## Service Information

Refrigerator integr.

**ARC 104/1/A+**

## Service Bulletin 4812 711 40347

**TITLE:** Unsticking push-in door gaskets.

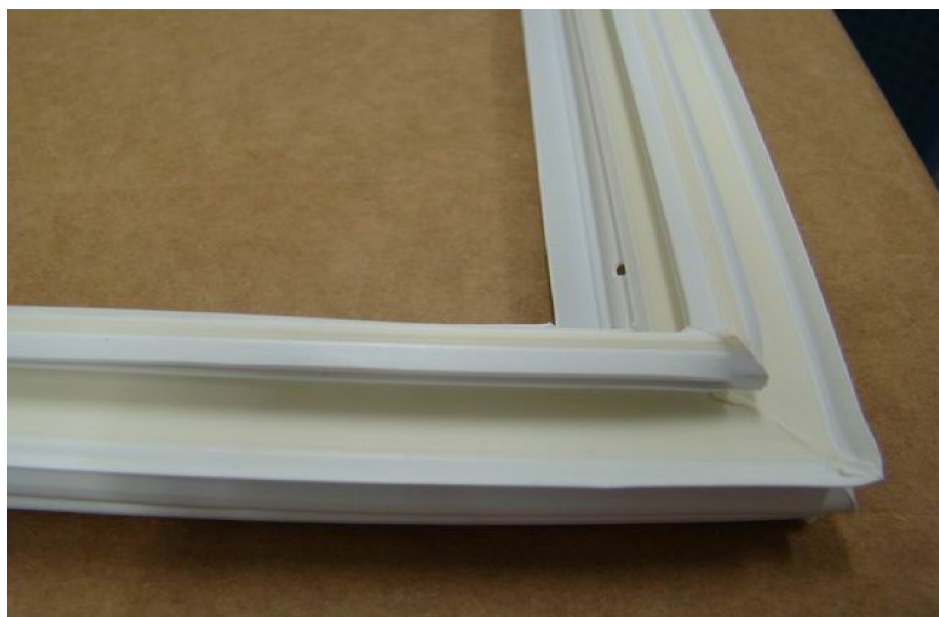
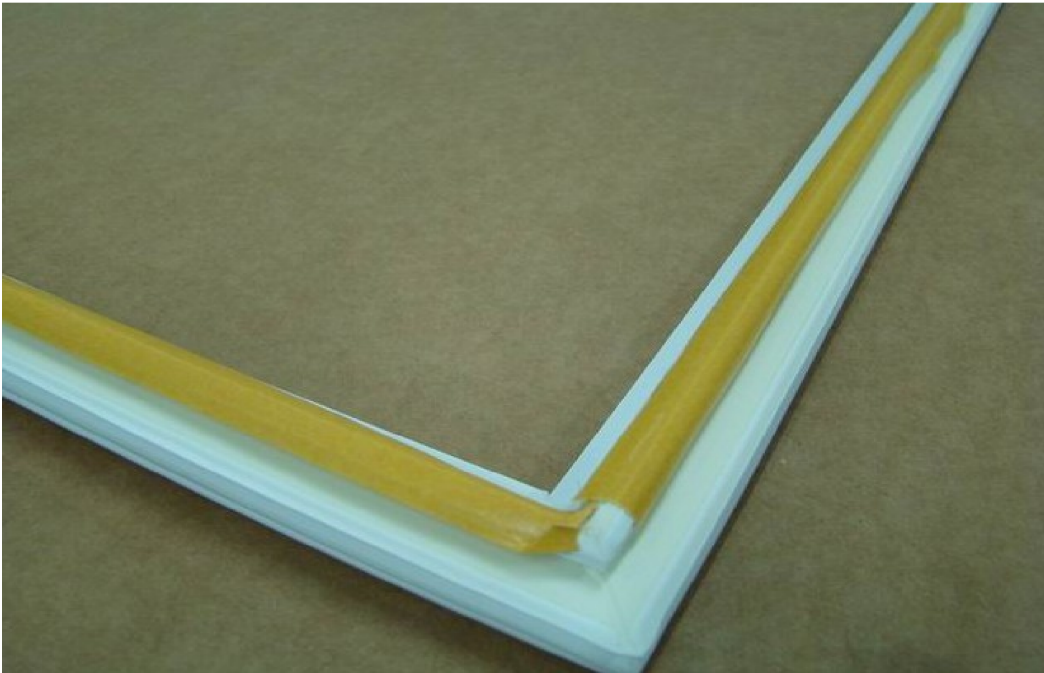
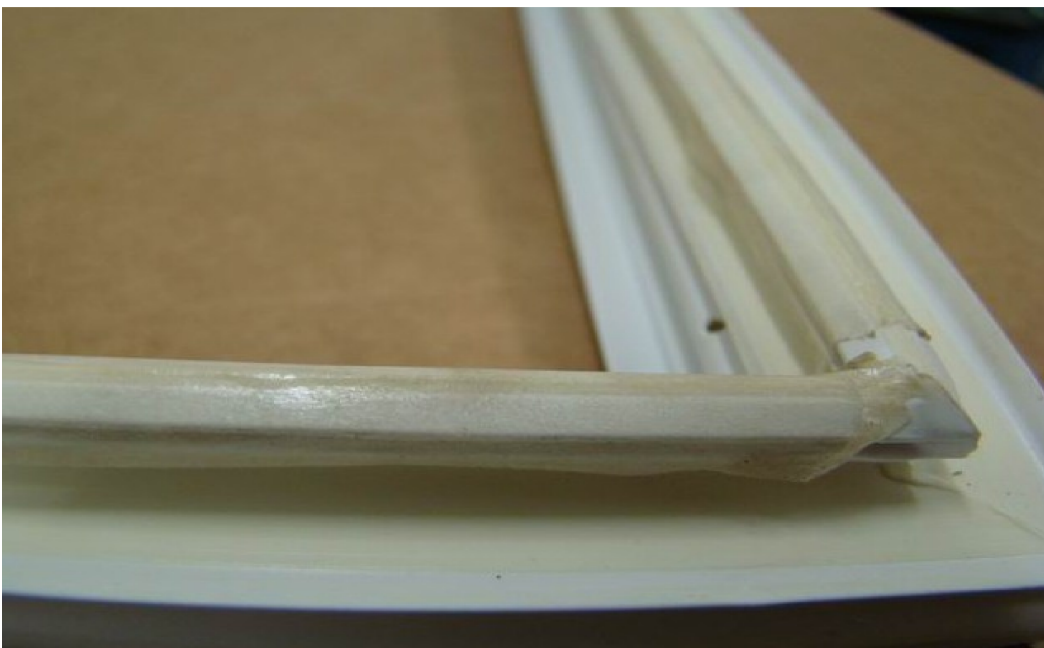
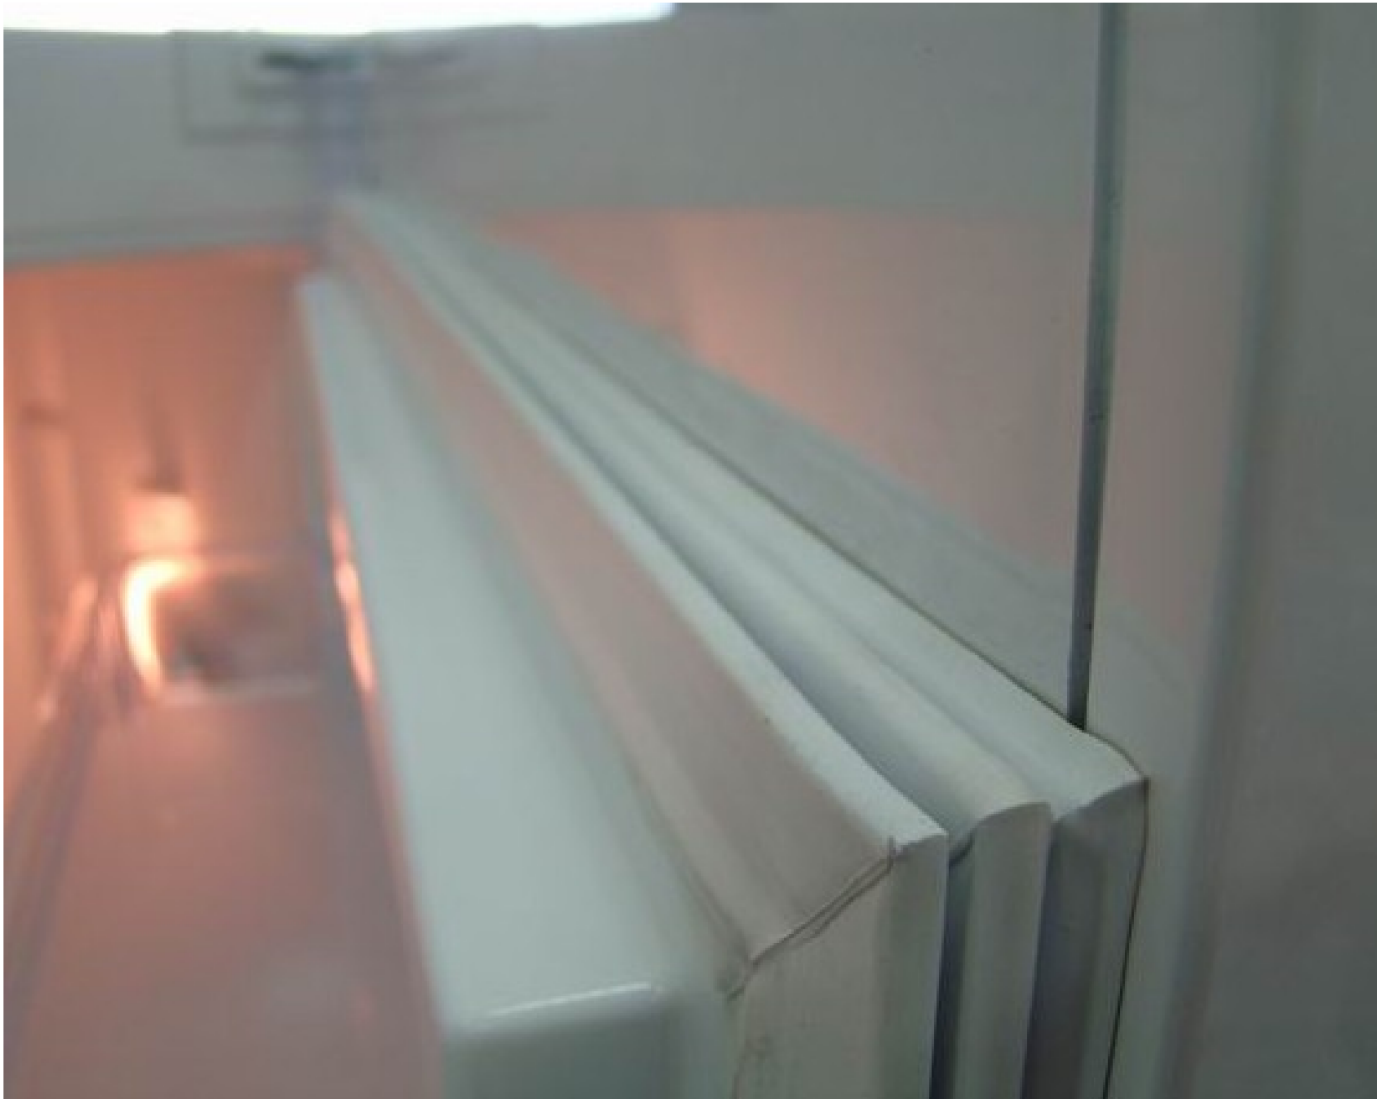
**SUBJECT:** In some cases it can happen, that the customer claims loosen door gaskets.

In case of loosen or unsticking push-in door gaskets, the technician can solve the problem by using a double adhesive tape from Tesa (15mm) with the order number 4812 291 08122. The estimated availability date in SPC is week 24/2010. See below the repair instruction.

Pull out the gasket from the door and place the gasket with the anker body side towards to the top on a base.

Step 2: Paste up the double adhesive tape on the anker body as shown below.

Step 3: Remove the second protection film from the adhesive tape.

Step 4: Press in the gasket to the gasket channel at the door.  
Start always from the corner side.

**TITLE:** Pipes vibration in the compressor niche.

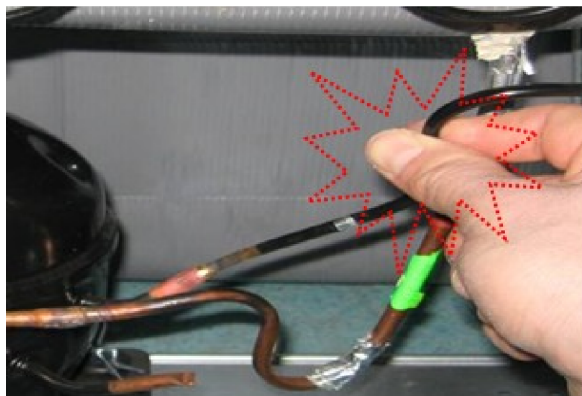
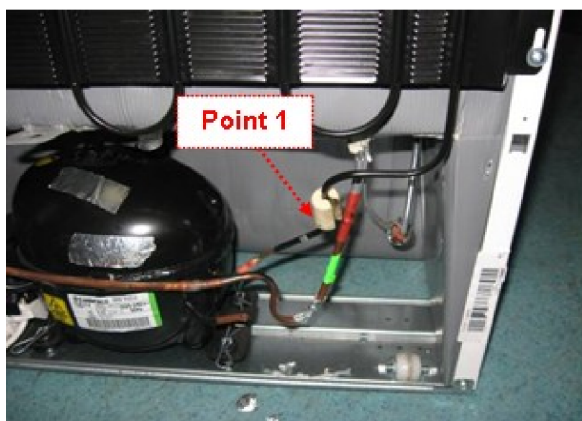
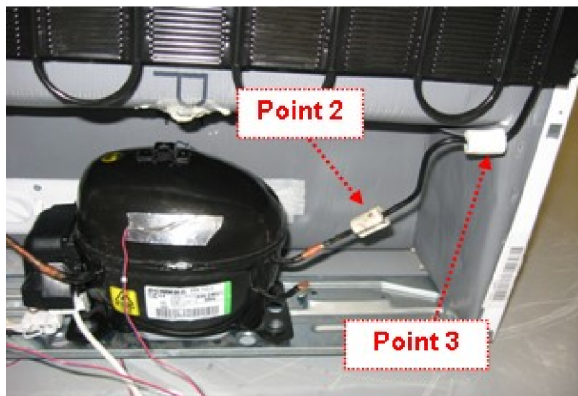
**SUBJECT:** In some cases the vibrations from compressor induce vibrations of pipes in the niche. Typically, it concerns to the discharge tube. As an effect a audible noise is generated by the tube.

To reduce the noise a damper should be applied. Therefore a kit was created with the order number 4801 321 02827. The kit consist of 3 damper. The availability date of the kit in SPC is week 11/2010.

By pressing the pipe with the fingers (hand), you can find out from which pipe the vibration is generated. By pressing with the fingers, it will reduce the pipe vibration noise.

This is the indication for the correct position to place the damper.

To reduce the noise a damper should be applied as show in the picture below.

There are also other points (2 & 3) along the pipe where the damper can be applied.
